TO: Winnebago Industries, Inc. Dealers

SUBJECT: Campaign #106 – Windshield Wiper Linkage

INSTRUCTIONS TO PERFORM CAMPAIGN 106

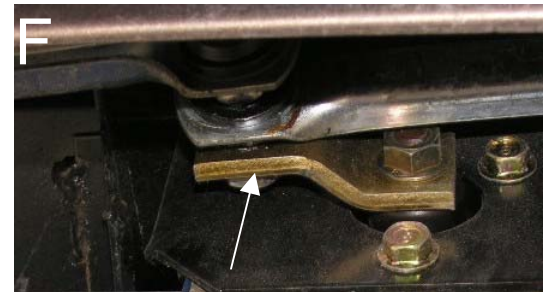
Install the passenger side wiper link arm (the longer link) first to the outside ball of the wiper motor drive arm and then to the passenger side pivot assembly. See Photo D.

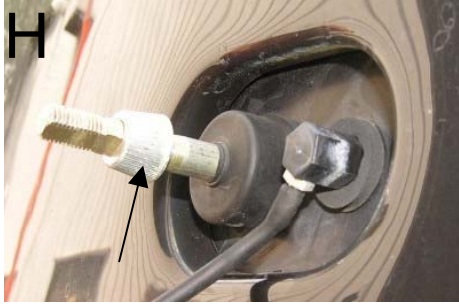
9. Reinstall driver and passenger side wiper arms on the pivot assemblies. Shown in Photo G.

Each notch on the spline shaft is 6 degrees. See Photo H.
